RFQ NUMBER
 DEP15737

LINE	QUANTITY	UOP	CAT NO.	ITEM NUMBER	UNIT PRICE	AMOUNT
0001	1	JB		962-73		\$1,193,400.00 \$1,168,400
RECLAMATION: RESTORATION OF WATER AND LAND THE WEST VIRGINIA PURCHASING DIVISION, FOR THE AGENCY, THE DEPARTMENT OF ENVIRONMENTAL PROTECTION'S OFFICE OF SPECIAL RECLAMATION, IS SOLICITING BIDS FROM QUALIFIED VENDORS TO PROVIDE ALL LABOR AND MATERIALS TO PERFORM RECLAMATION ON THE MINING OPERATION OF LANDMARK CORP. UNDER REVOKED PERMIT NUMBER S-34-82 ON A SITE OF APPROXIMATELY 15 ACRES LOCATED NEAR JULIAN, WEST VIRGINIA, (BOONE COUNTY). THE RECLAMATION SHALL BE PERFORMED UNDER THE GUIDANCE AND GENERAL SUPERVISION OF THE AGENT ASSIGNED TO THE PROJECT FOR THE STATE OF WEST VIRGINIA, DEPARTMENT OF ENVIRONMENTAL PROTECTION. A MANDATORY ON-SITE PREBID CONFERENCE SHALL BE HELD ON 03/20/12 @ 10:00 AM. ALL INTERESTED PARTIES ARE REQUIRED TO ATTEND THIS MEETING. FAILURE TO ATTEND THE MANDATORY PRE-BID SHALL RESULT IN DISQUALIFICATION OF THE BID. NO ONE PERSON MAY REPRESENT MORE THAN ONE BIDDER. AN ATTENDANCE SHEET WILL BE MADE AVAILABLE FOR ALL POTENTIAL BIDDERS TO COMPLETE. THIS WILL SERVE AS THE OFFICIAL DOCUMENT VERIFYING ATTENDANCE AT THE MANDATORY PRE-BID. FAILURE

SHEET 4 OF 5

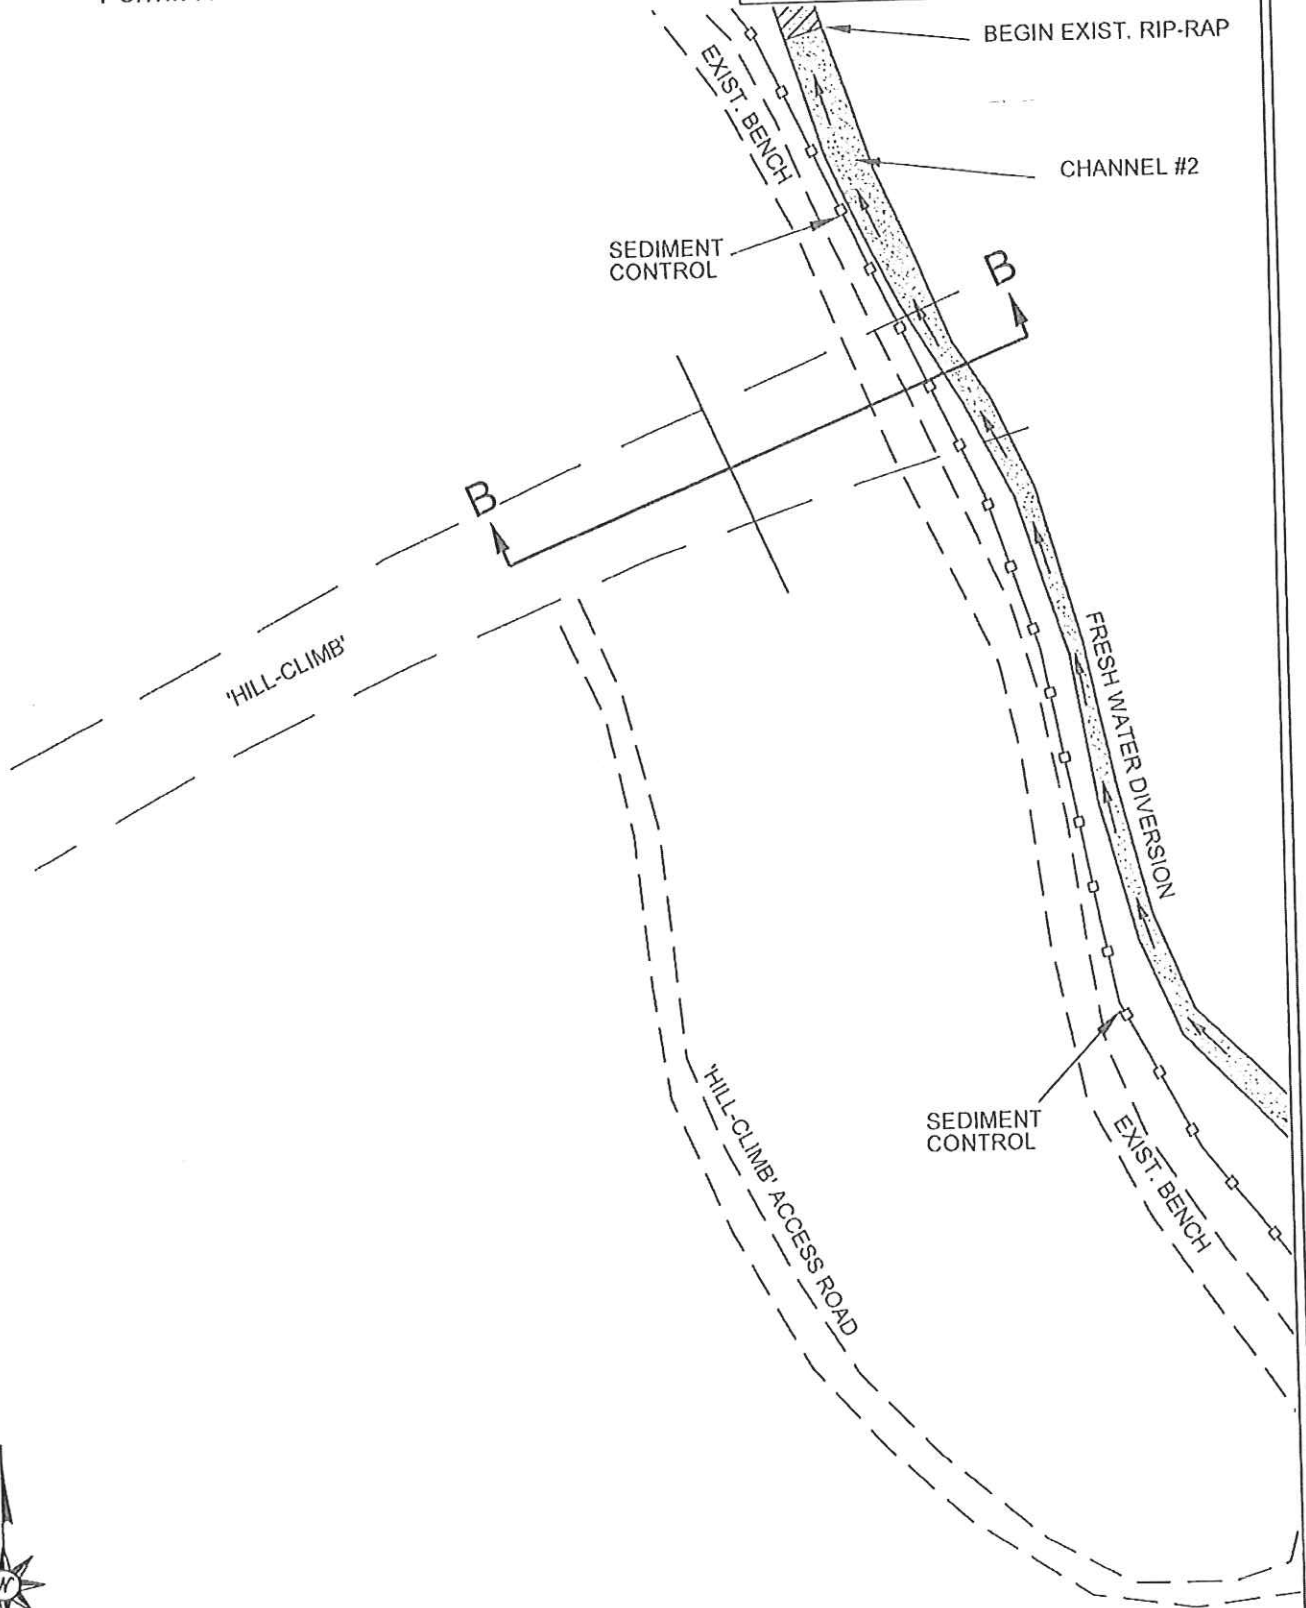
Drawings #3 and #4 (pp. 23 and 24) are revised to show the lining of the lower 375 LF of Channel #2 as existing rip-rap.

CLARIFICATION: The total length of the existing fresh water diversion ditch earmarked for work under this project, designated as Channel #2, is 1,250 LF. Of this length, the lower 375 LF has existing sandstone rip-rap. The upper 875 LF is shaped into the fill material with no existing rip-rap or other liner (except for natural vegetation) in place. Per the revised specification, the entire channel, as delineated on the plan, shall be cleared of all obstructions (such as trees, pipes, boulders, washed in sediments, etc.) and be free-flowing. All obstructions shall be removed such that the final cross-sectional shape of the cleaned section conforms to the cross-sections of the channel immediately upstream and downstream of the cleaned section. The entire channel length of 1,250 LF shall then be lined with 3-inches of 1-1/2" limestone crusher run for the full channel cross-section. No new rip-rap placement work will be required except where the existing rip-rap is displaced or damaged by the cleaning activities. Such rip-rap repair work will be incidental to this bid item. Revised specifications for Item 12.2 are attached, deleting all reference to new rip-rap placement work (except for rip-rap repair work associated with and due to Channel #2 cleaning).

DRAWING NO.:	5
--------------	---

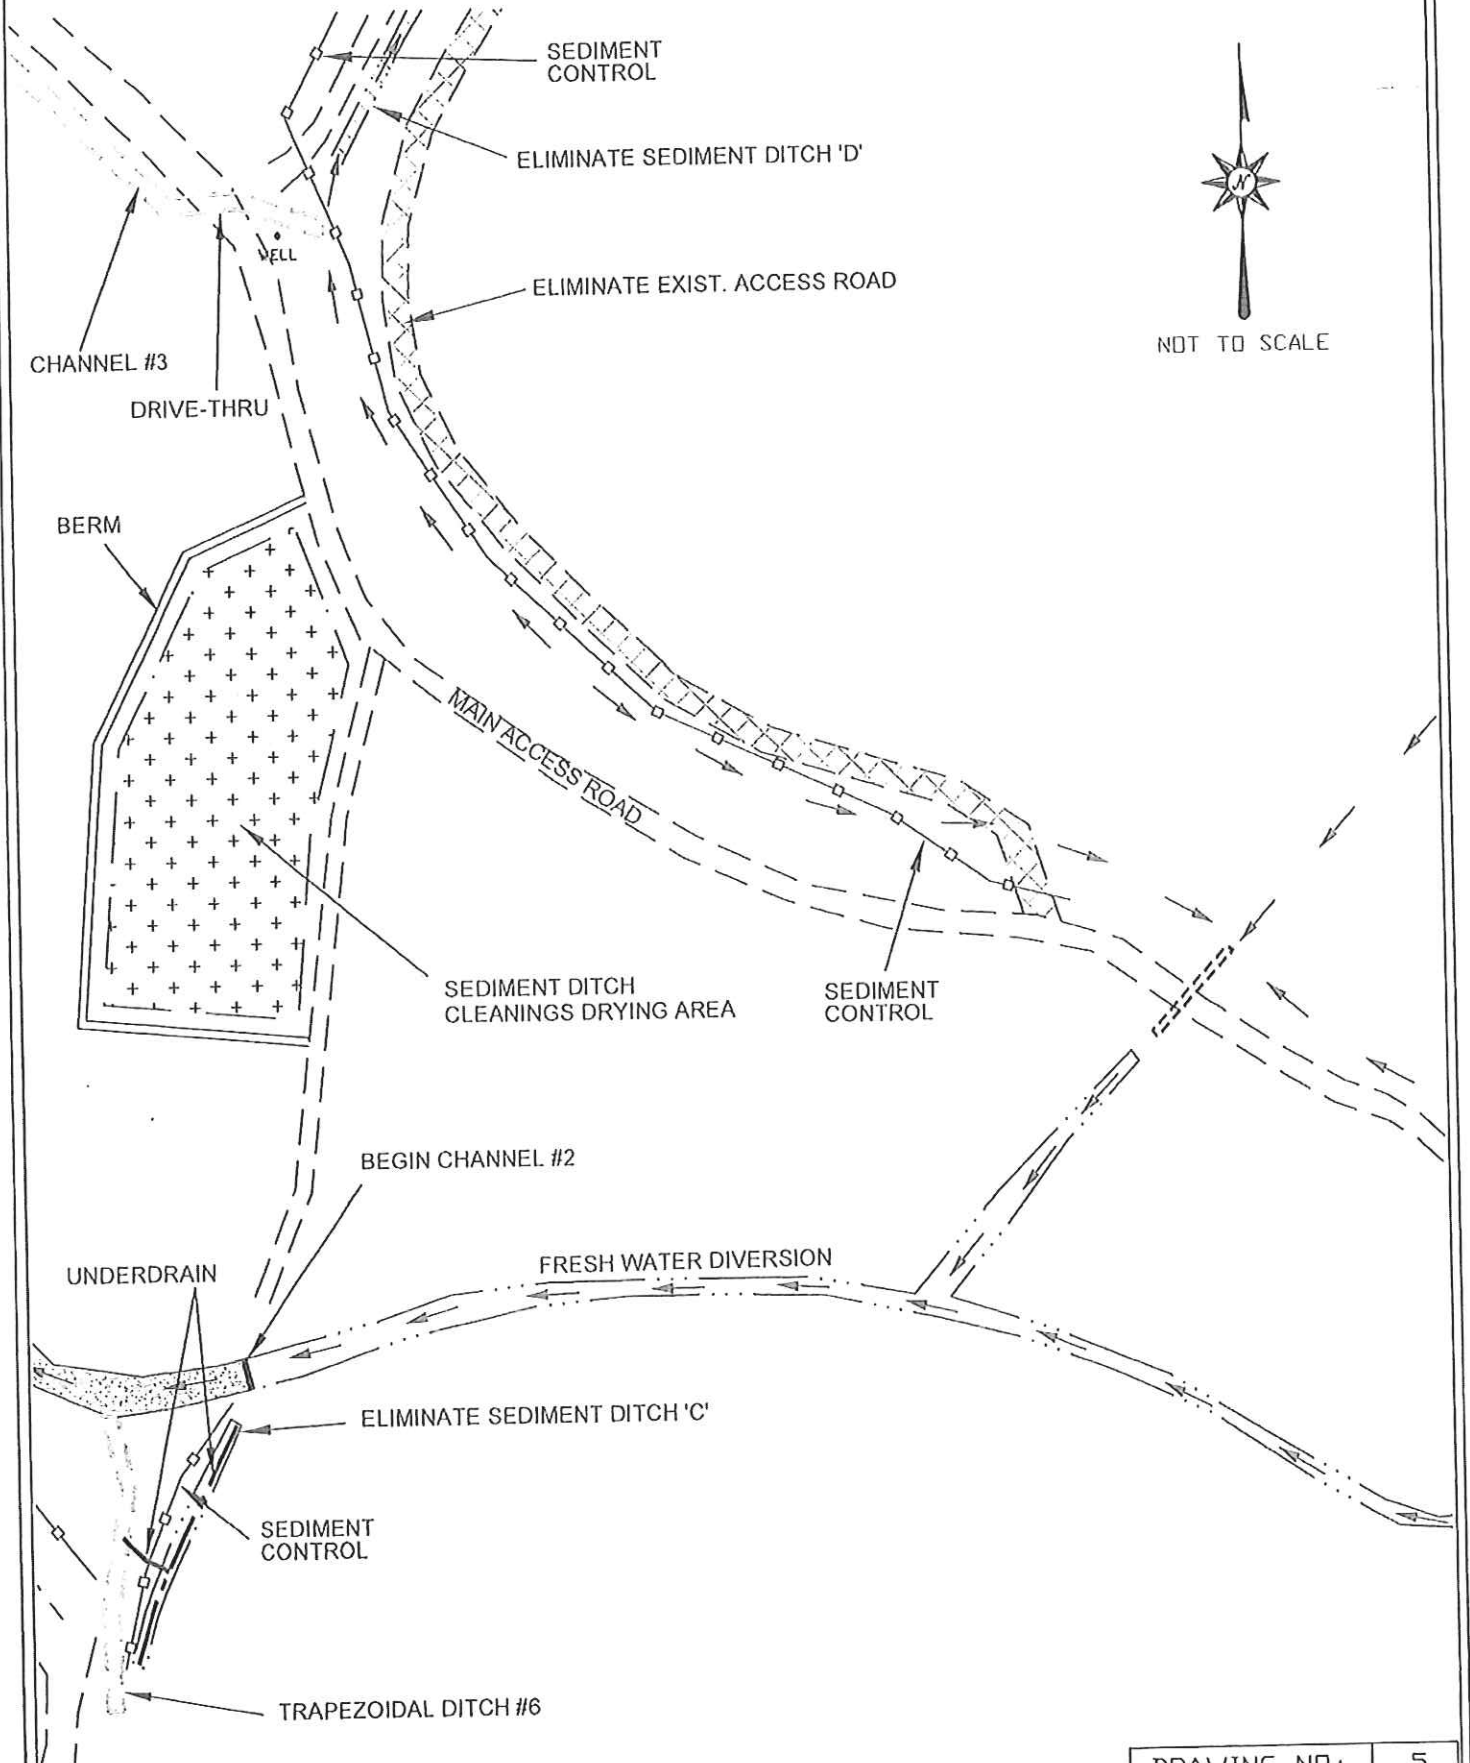
Drawing #5 (pg. 35) is revised to list the proposed proper lining for Channel #2.

Drawings #3 and #5 (pp. 23 and 25) are revised to show the new location of Channel #3. Drawing #15 (pg. 35) is revised to add a drive-thru for Channel #3 across the main access road.

BUYER GN-23	PAGE	REQ. or P.O. No. DEP15737
SED. DITCHES 'E' & 'F' TYP. SECT. C-C

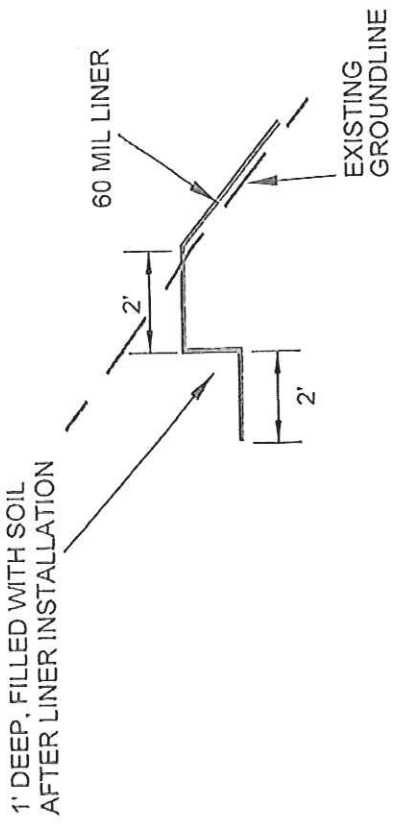
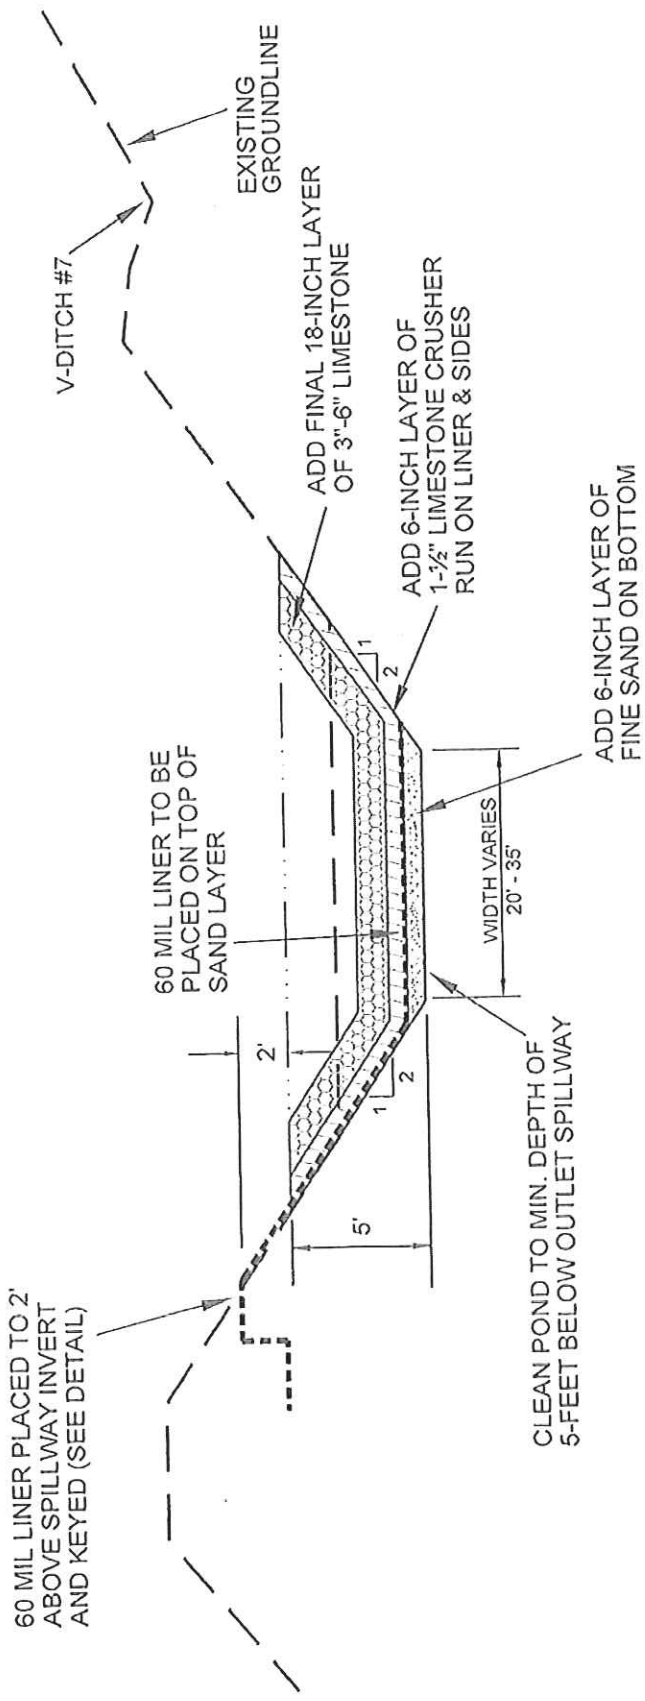
Drawing #20 (Page 40) of typical Section C-C is revised to describe the bottom width for the ditches as ranging from 20' to 35' wide.

CLARIFICATION: Sediment Ditches E and F are estimated at 420 LF and 350 LF, respectively. The final sediment ditch width will be the same as that which currently exists. The ditches will be cleaned and lined to their current width with liner covering the entire bottom and lower side as shown on the typical section (Drawing #20). It will be the responsibility of the bidder to determine the exact amount of materials required to complete the work under this bid item.
